AGENDA
CITY OF CREVE COEUR
PLANNING AND ZONING
300 NORTH NEW BALLAS RD
SEPTEMBER 5, 2023
6:00 PM

1. PUBLIC HEARING: Application #23-031: A Conditional Use Permit for a Warehouse/Storage Use Located at 1145 North Warson Road

2. PUBLIC HEARING: Applications #23-027 and #23-028: Applications for a Rezoning From "RO" Research Office District to the Olia Village "PMD" Planned Mixed-Use Development District with a Site Concept Plan and Phase One Site Development Plan with Associated Preliminary Plat for the 96 Acre former Bayer West Campus at 10300 Olive Boulevard

A-103.2

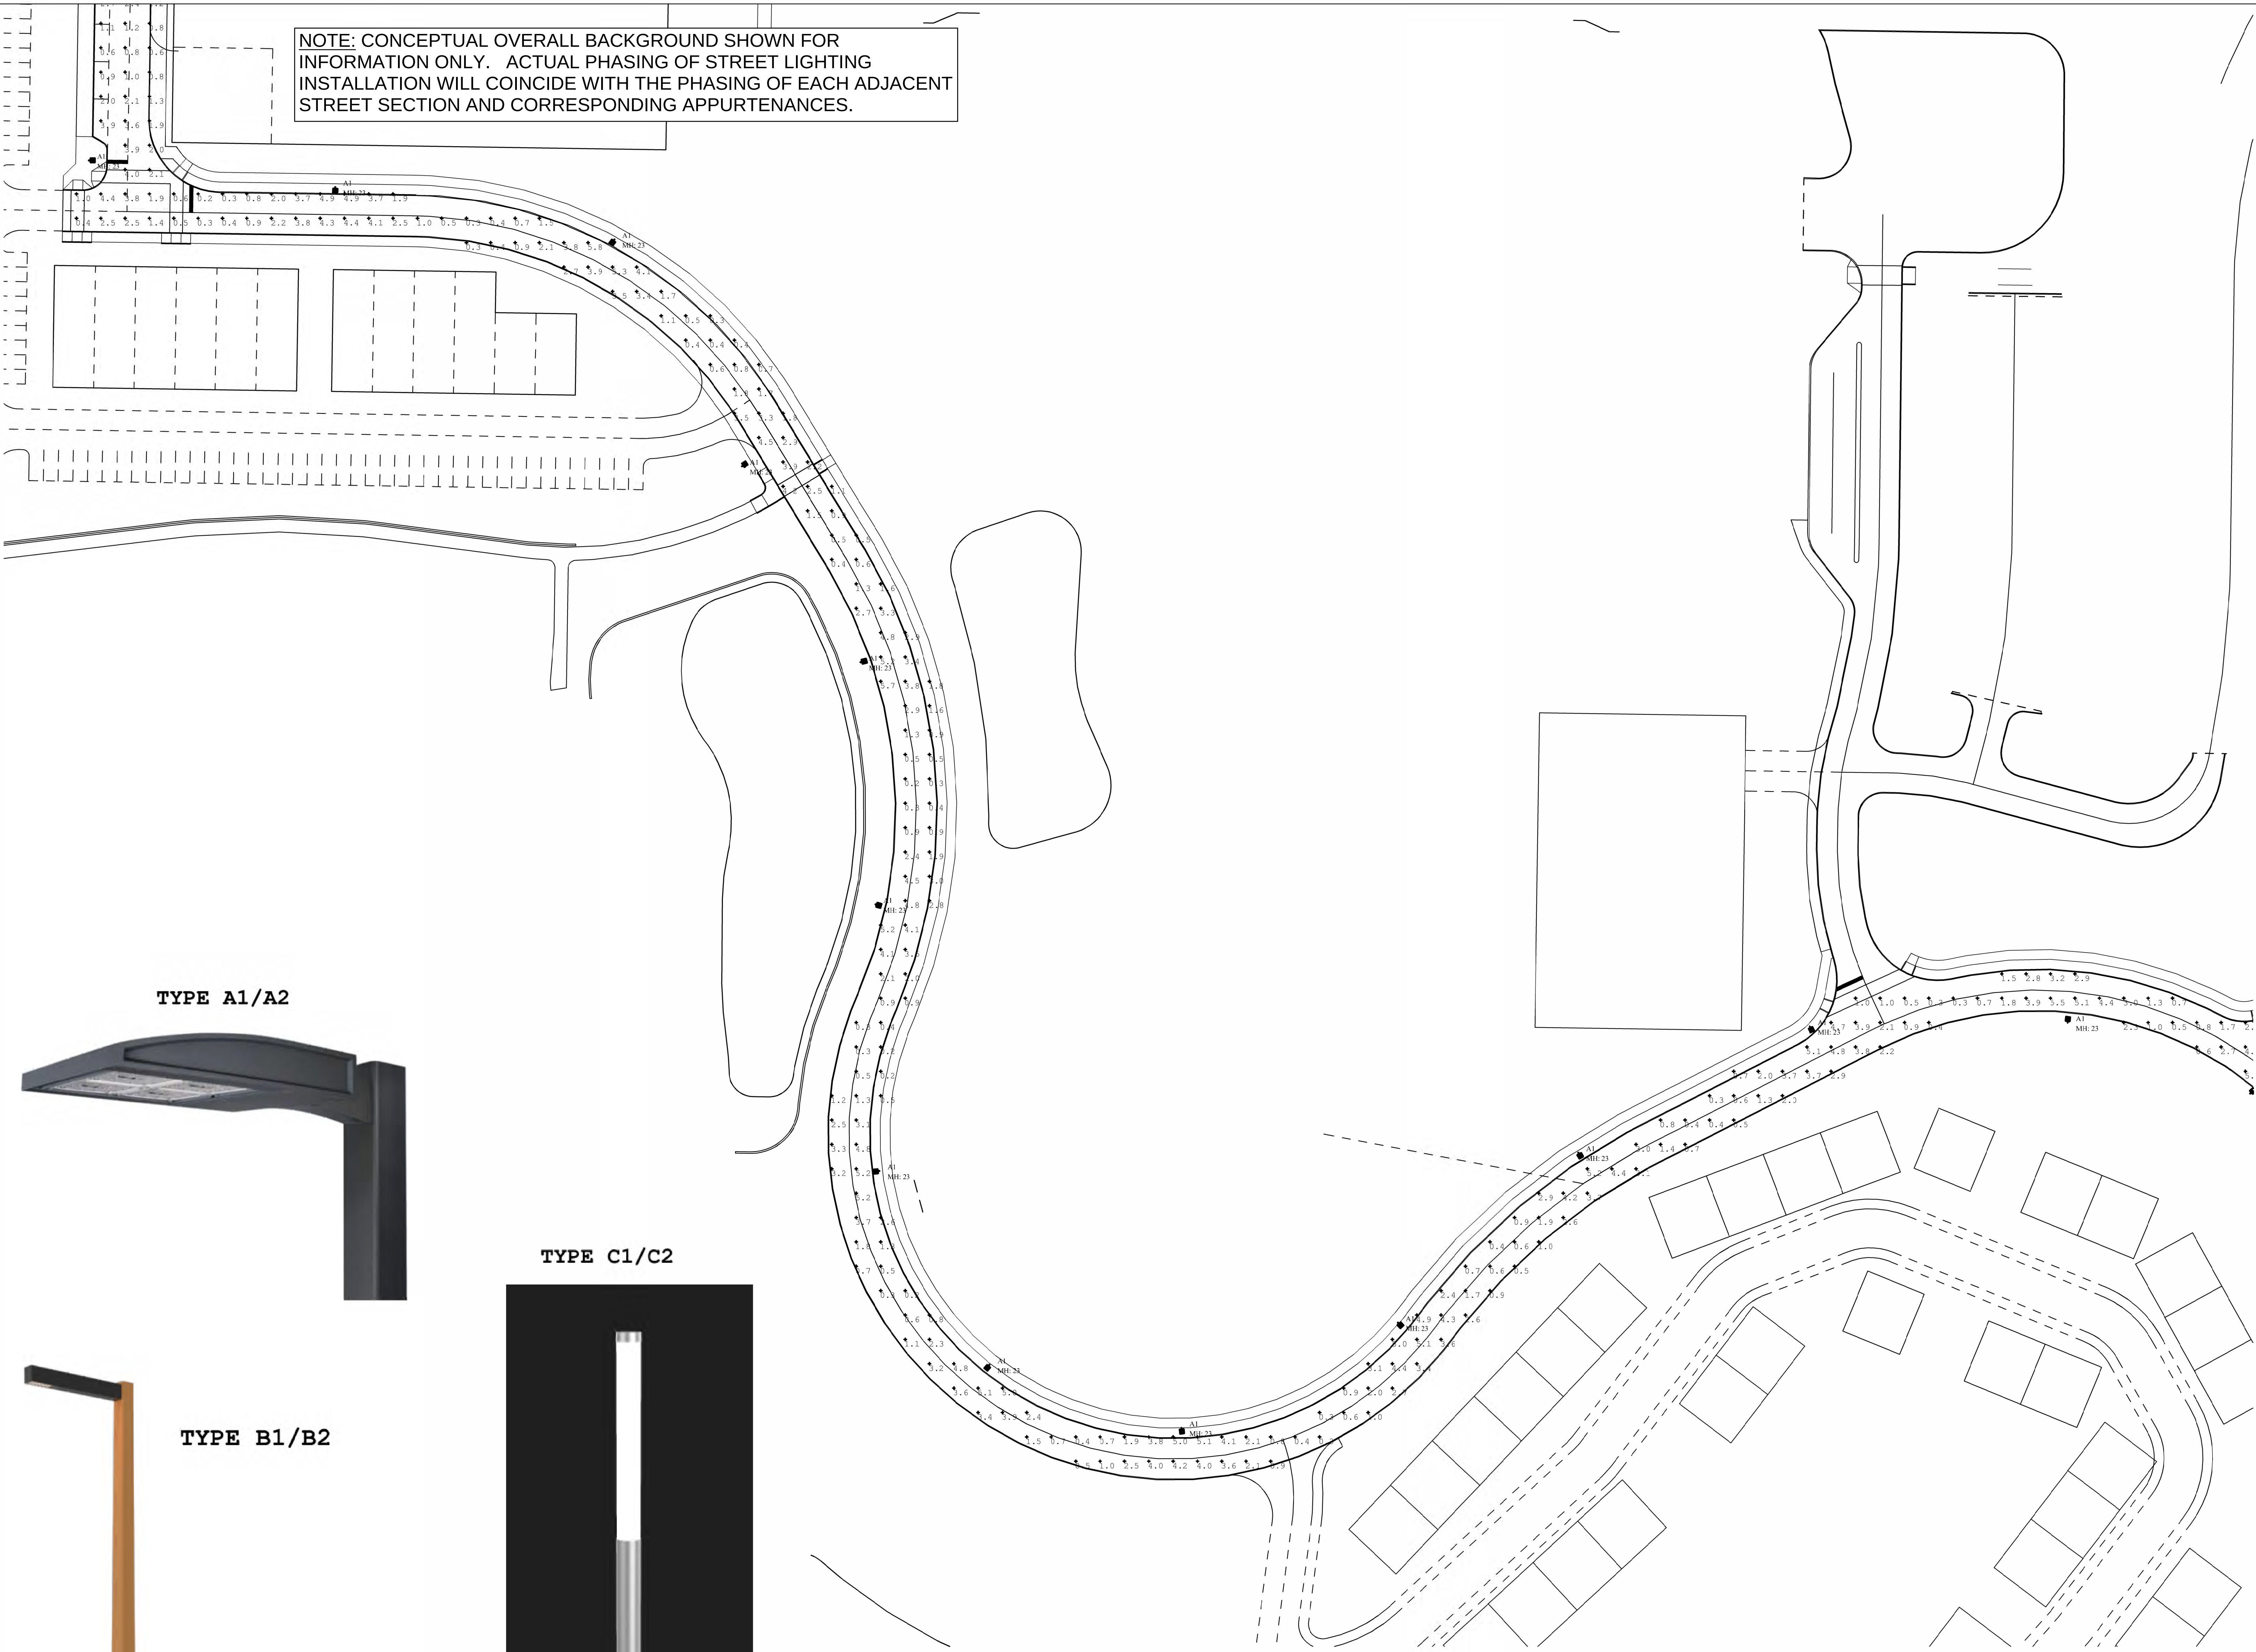
7. Phase 1 Site Development Plan. Site Lighting (Street Lighting). Sheets A-103.1-4. Street light standards appear to be shown on private property within an easement. Will the street lights be privately owned and maintained?

C-101

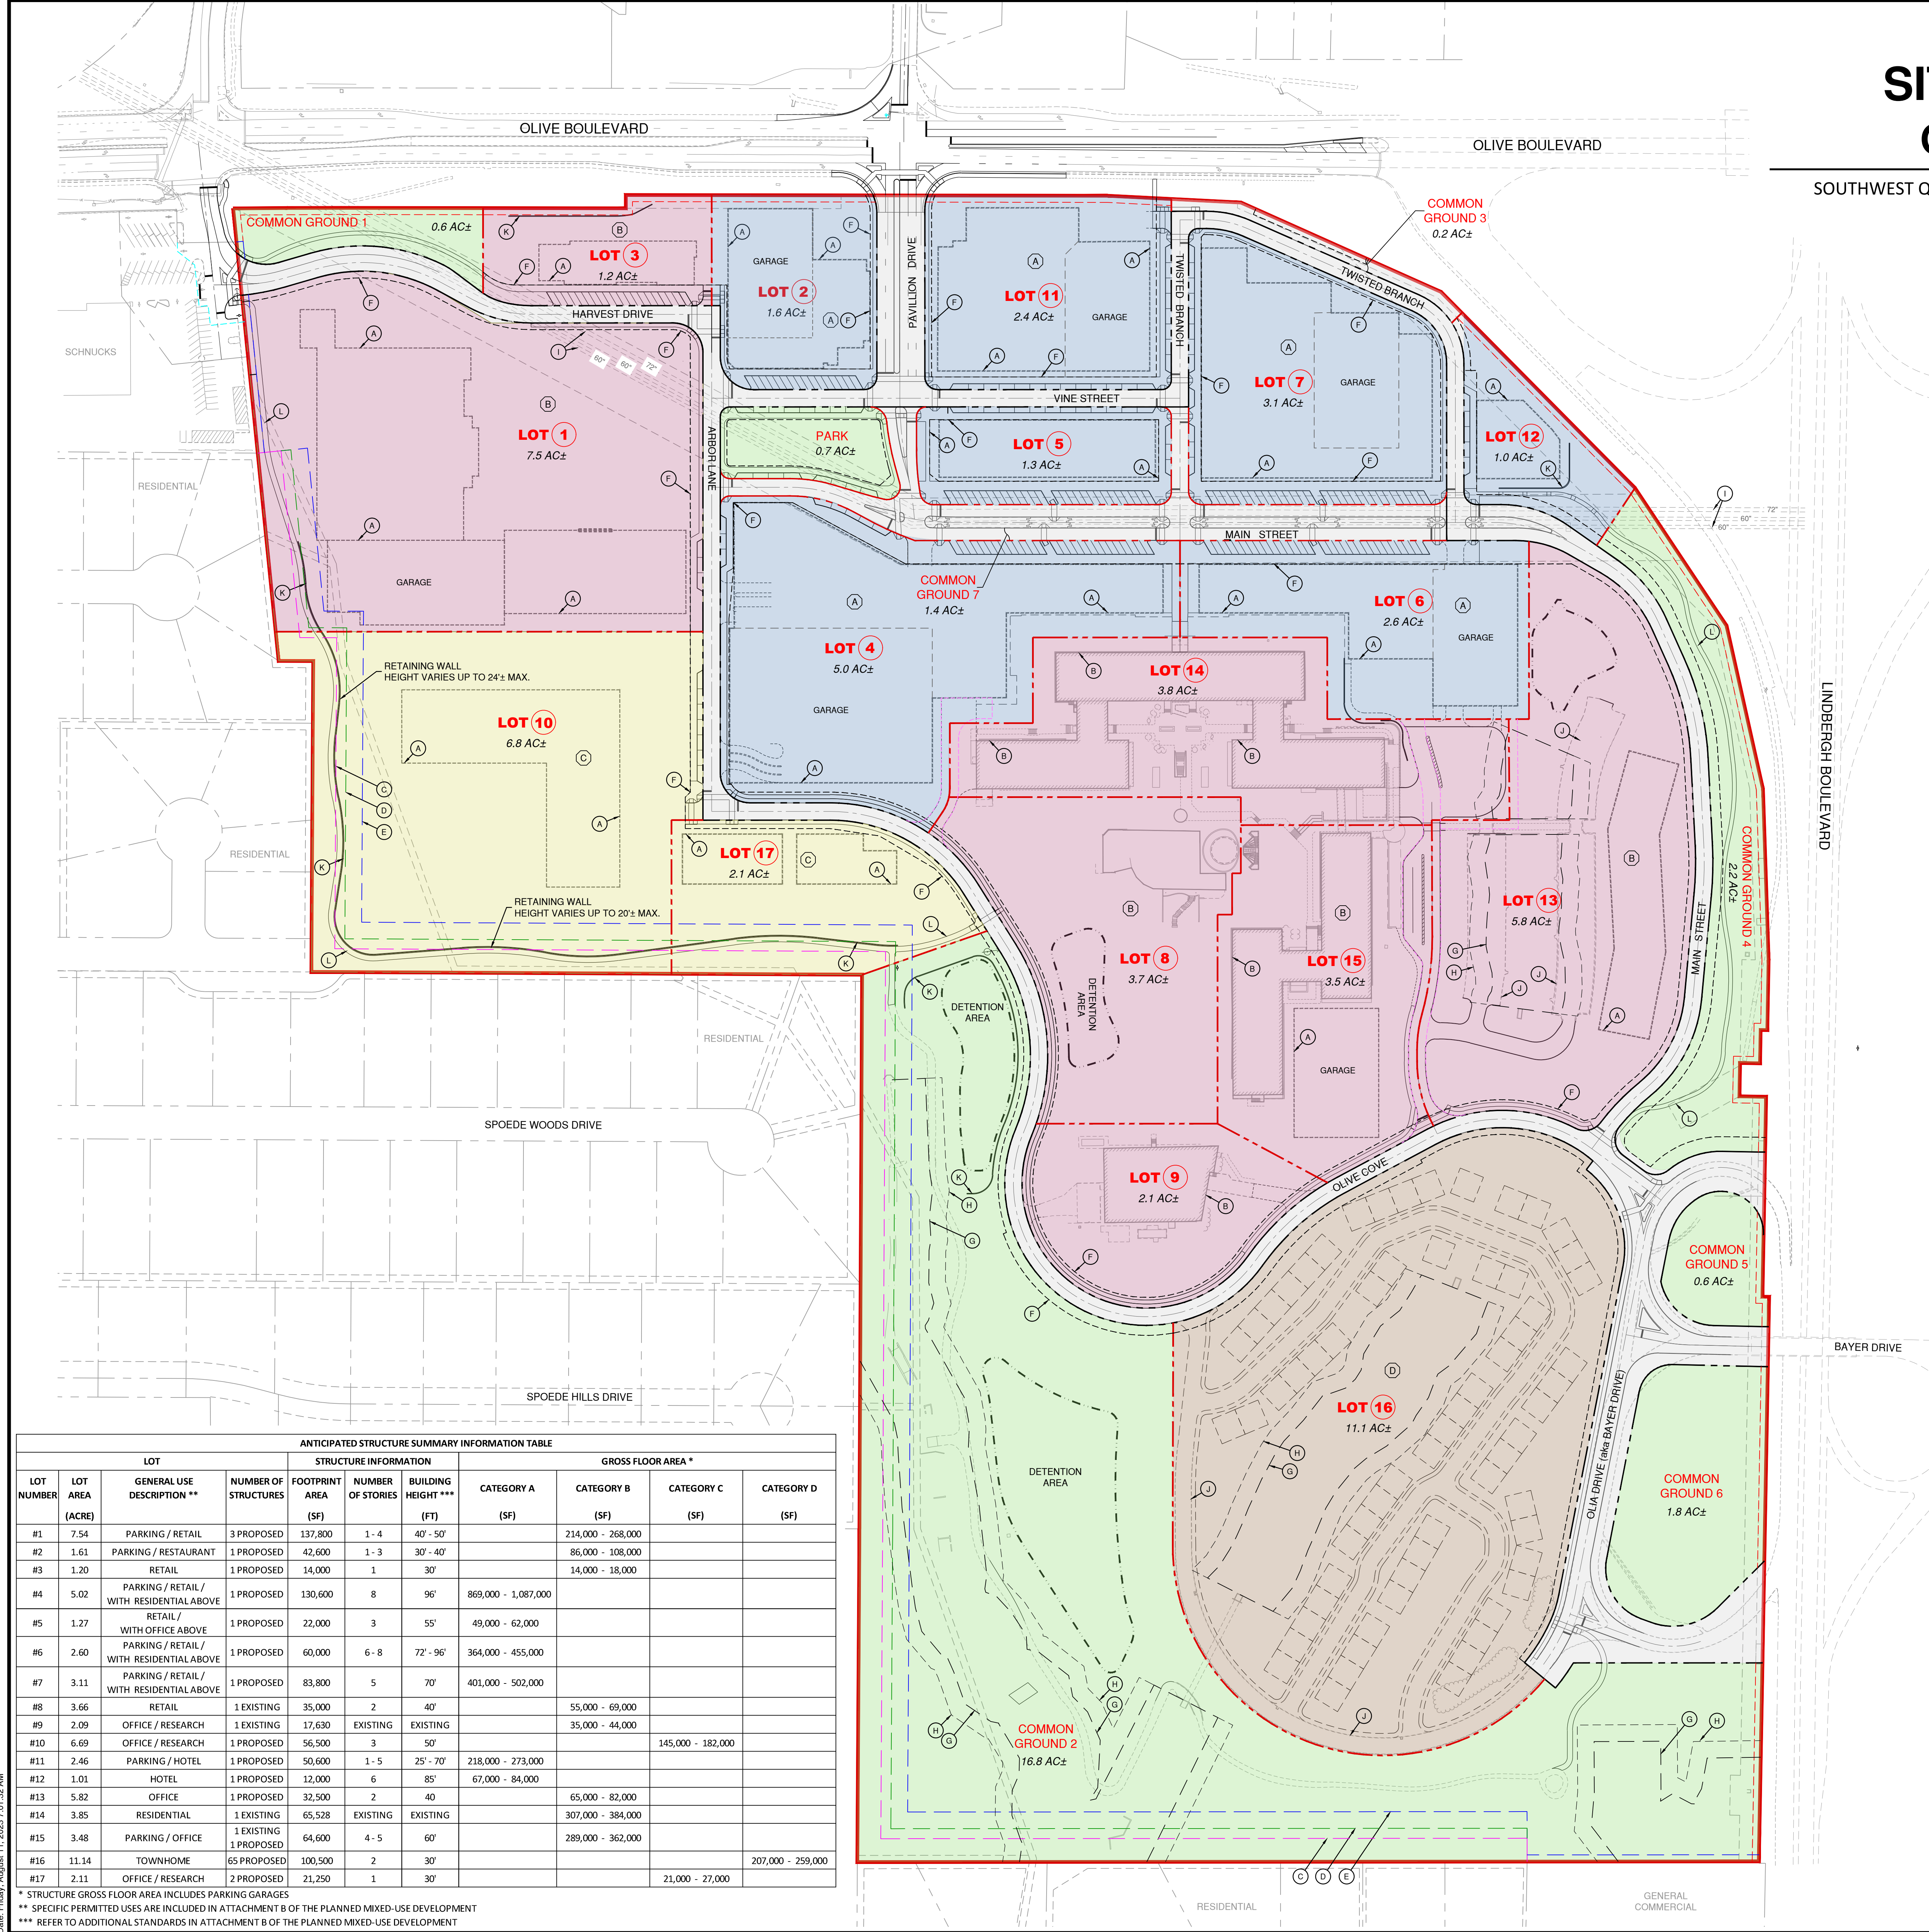
10. Sheet C-101: Maximum Height of all buildings. Add note on plans to refer to additional standards in "Attachment B".

Olia Team Response: A note has been added to the bottom of the table on Sheet C-101.
